Subject: EPA Comments on WI Power & Light Co - Edgewater Generating Station,
Sheboygan, WI
Round 10 Draft Assessment Report

**Re: Response to Draft Assessment Report
Edgewater Generating Station**

Subject: **Edgewater Generating Station Ash Ponds Supplemental Report
In Response to GZA Review of Miller Evaluation of Embankment Stability**

S
609.7

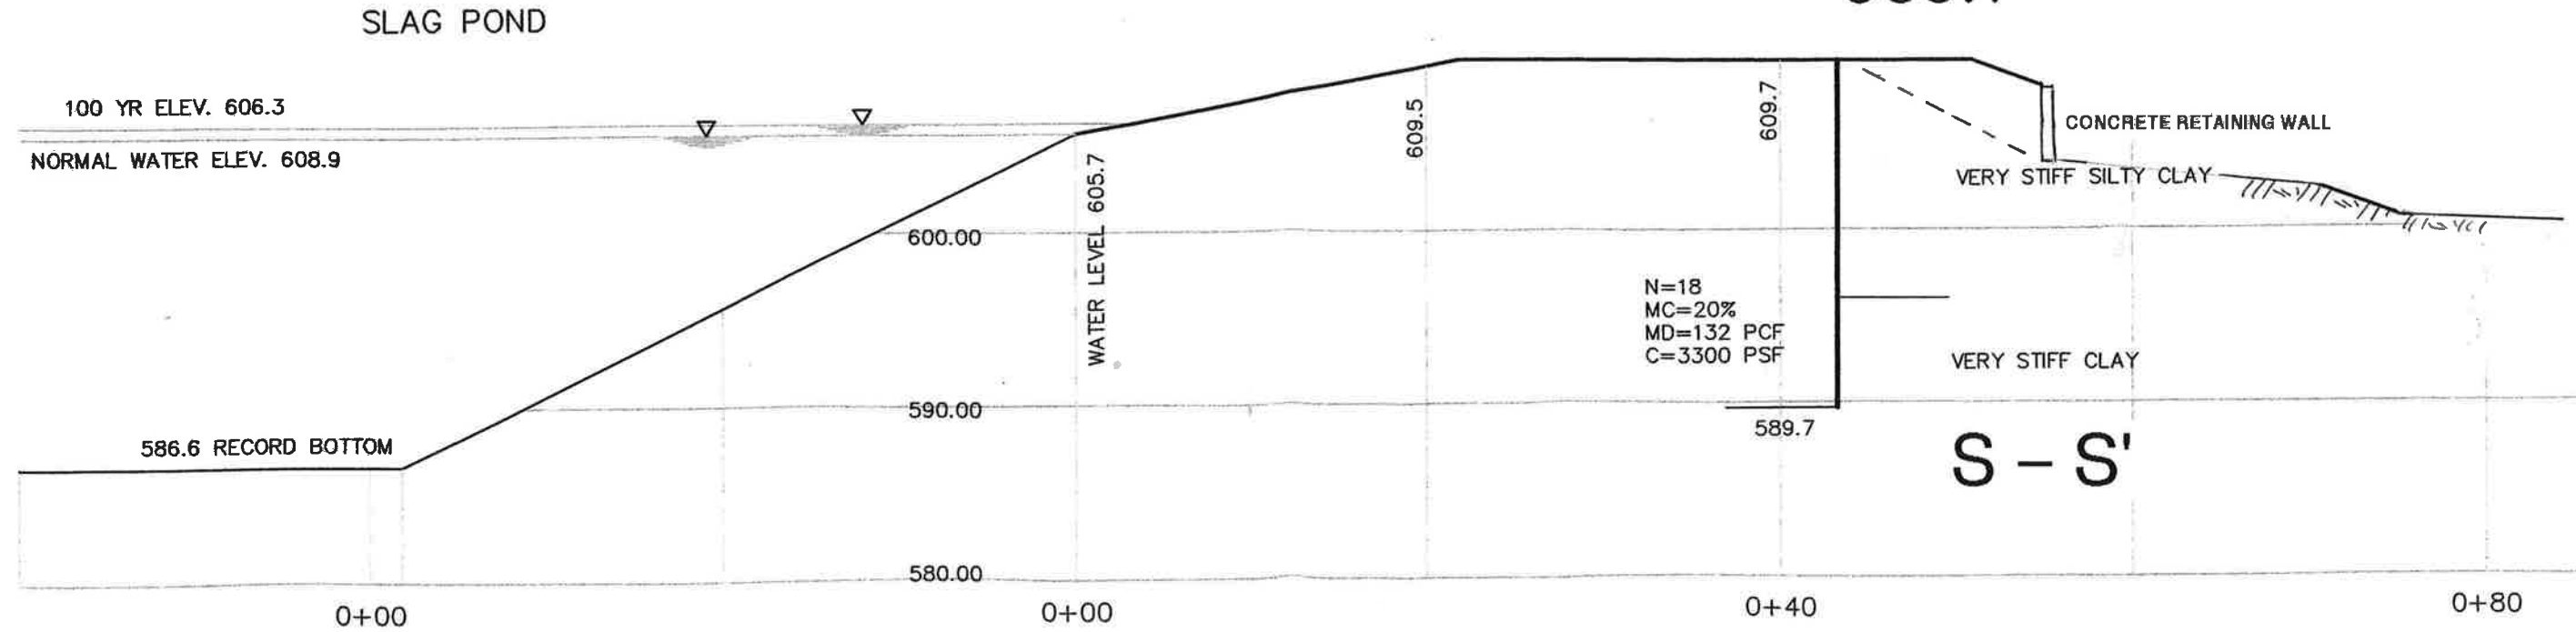
The four feet high concrete wall accommodates a wide haul road bed and is not a necessary element of the slag pond berm. The wall is in good condition, but has at least one vertical shrinkage crack that does not affect its stability. To comply with GZA's recommendation and demonstrate it is not a necessary element of the berm for purposes of containing water in the Slag Pond, **we performed stability analysis using Janbu's charts of Berm Section S under the presumption that the concrete retaining wall is not present; yielding a safety factor of not less than about 16.** This demonstrates that this section is not critical, irrespective of the condition or existence of the concrete wall.

P
609.7

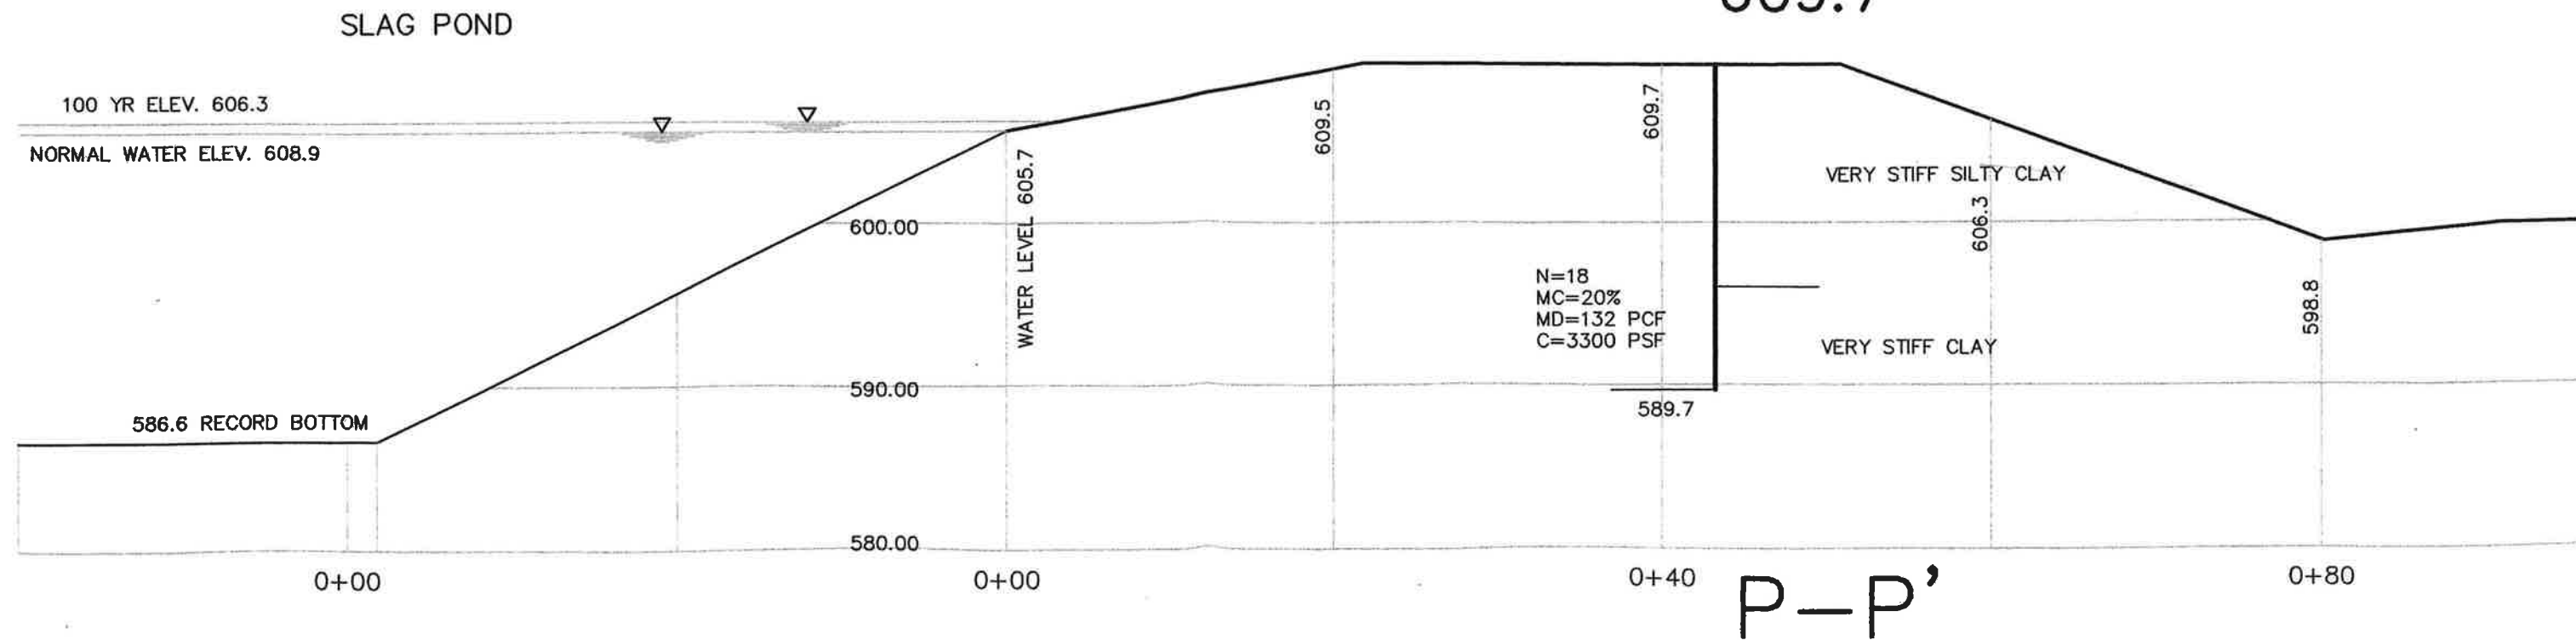
Our prior report included stability analysis of the most critical section of the north side of the Slag Pond, which is its inside slope under rapid drawdown condition. For that we had computed a factor of safety of 6.3. This is labeled Section P and is located east of the portion of this berm that has the retaining wall on its outside (north side), which we have labeled Section S. These features are shown in plan view on the attached *Figure 1. Cross Sections* are shown on an 11" x 17" sheet and the attached *Site Photographs* show the field conditions.

SECTION E - STATIC CONDITIONS: FOS=2.35

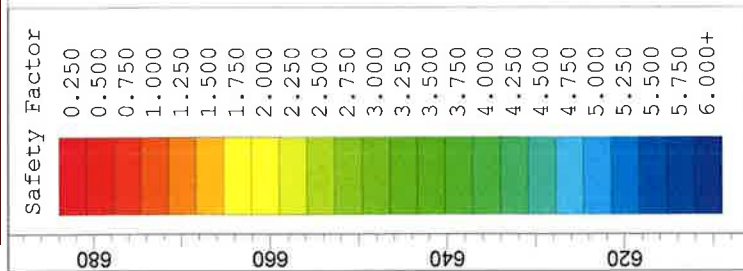
Rapid drawdown in Section E, which we presented in our prior report as its most critical static condition, can only occur with active pumping. That would not be coincident with an earthquake. So, in this supplement, we include both static analysis without rapid drawdown along with PS analysis for this same section to directly show the small effect that the seismic coefficient has in an area such as this with low seismic potential:

Section E Static Factor of Safety = 2.35
(min. required 1.3)

10-18634 50-200 - Alliant Edgewater Slope Stability			
Cross Section E - Pseudo-Static Analysis			
Analysis Description	Scale	Company	Miller Engineers & Scientists
Drawn By	1:260		
Date	7/27/2012, 2:21:03 PM	File Name	Alliant Cross Section E - pseudo.slim

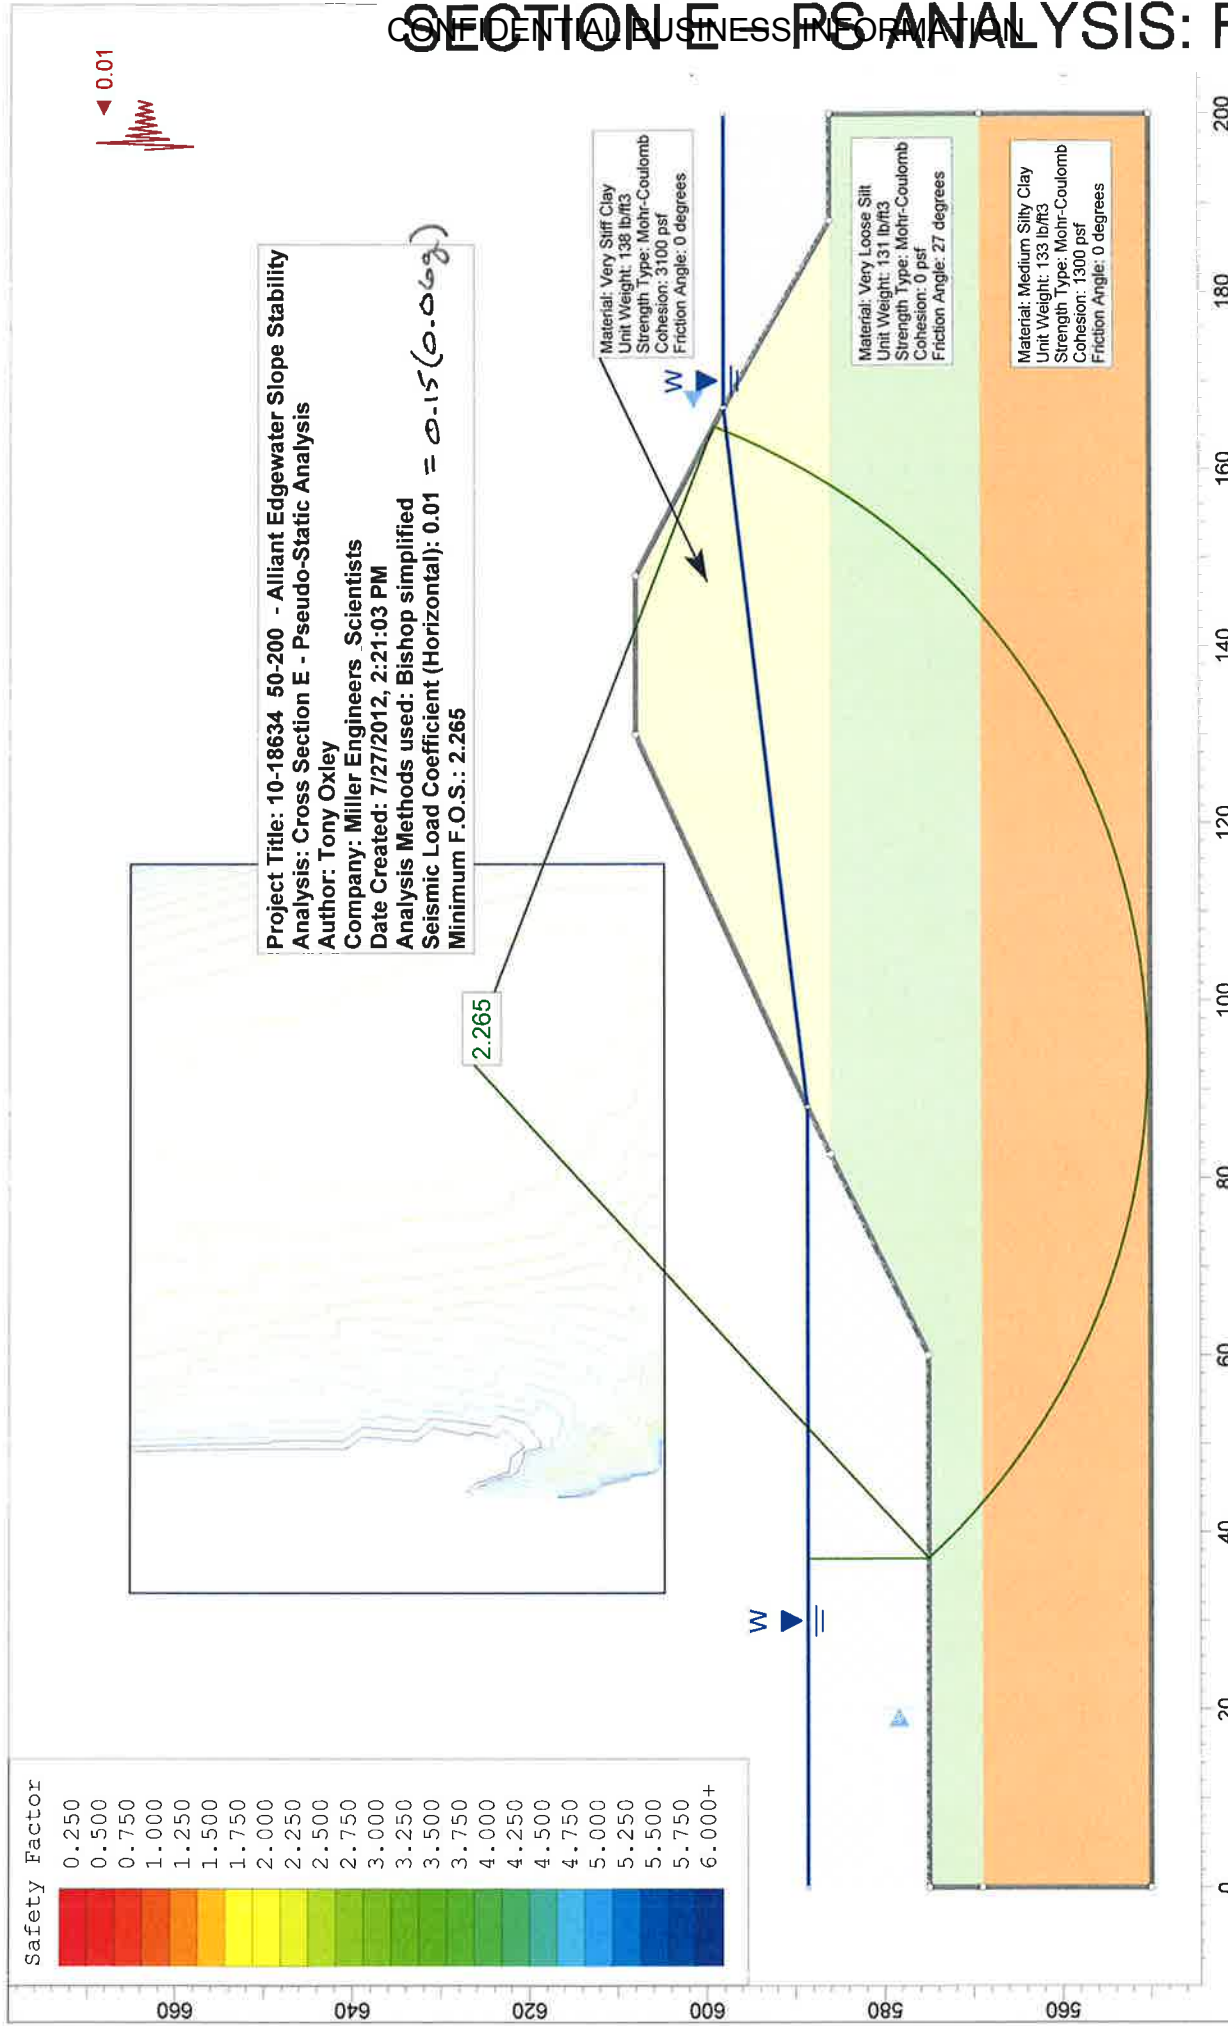
Section E Pseudo Static (PS) Factor of Safety= 2.27
(min. required 1.1)
